SOUTH COAST AIR QUALITY MANAGEMENT DISTRICT

Draft Staff Report

Proposed Amended Rule 1147 - NO_x Reductions from Miscellaneous Sources

March 2022

Figure 2-12 – Capital Costs for Equipment and Installation

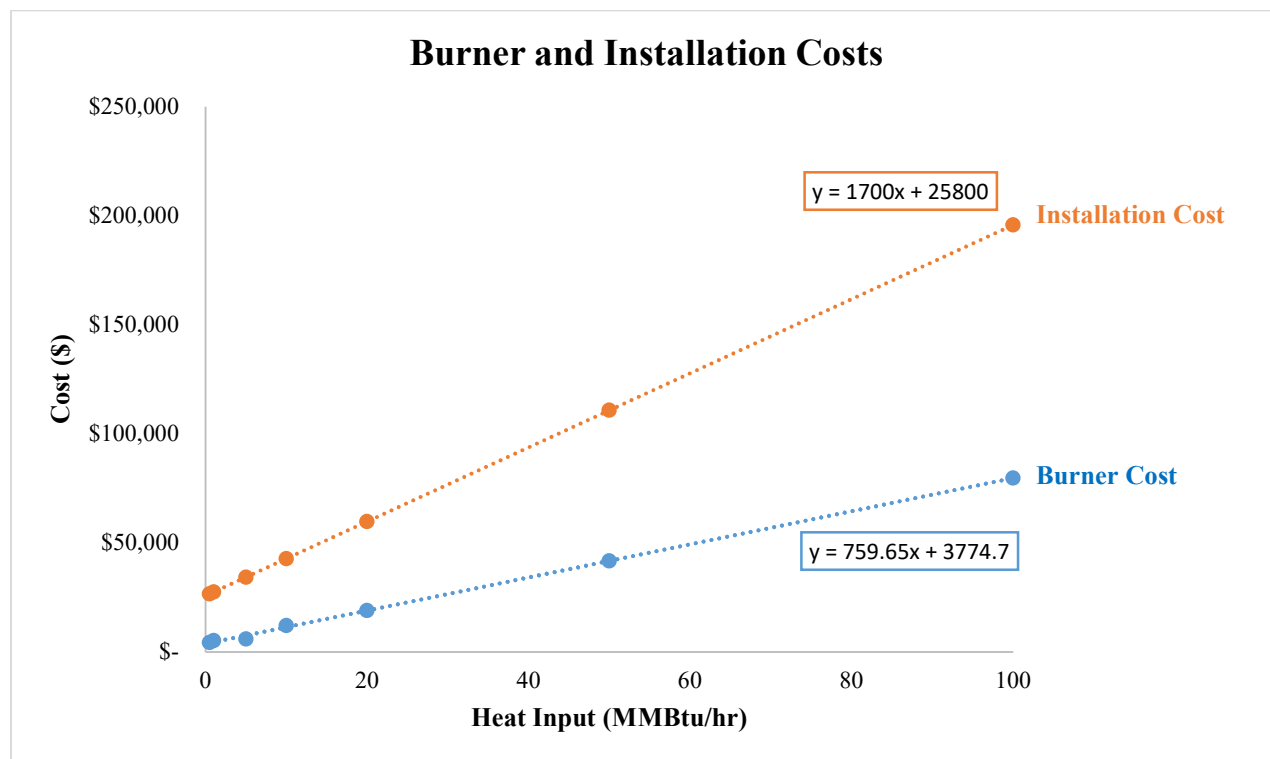
- 4) Page 2-17 indicates that without the use of AER information a national capacity factor be applied of 80%. The question is, does this number refer to a production output of the plant product or the BTU input of the equipment. We have looked at a variety of different industries – forging, heat treating, autobody heated booths, powder coating, etc. We looked at the PTE of all the devices in the plant and compared that number with the Gas Company invoices to determine the % of PTE actually realized. Those numbers ranged from 10.65% to 19.9% PTE. Staff has this information based on the AERs presented. We feel the 80% has no relevance to combustion equipment utilization.

Cost effectiveness methodology is outlined in Chapter 2 of this staff report including the method used and comparison between discounted cash flow and levelized cash flow. Equipment cost as well as installation cost curves are shown in Figure 2-12 of this staff report. Category specific average for cost effectiveness as shown in Table 2-2 of this staff report is calculated using a bottom-up approach which considers individual equipment costs. As part of the cost effectiveness analysis, staff calculates emissions for equipment usage based on either actual emission such as AER reported emissions or the average industrial production and capacity utilization released by the United States Federal Reserve printed on February 7, 2011¹². The average capacity utilization of 80% was only used if real world emissions data was not available.
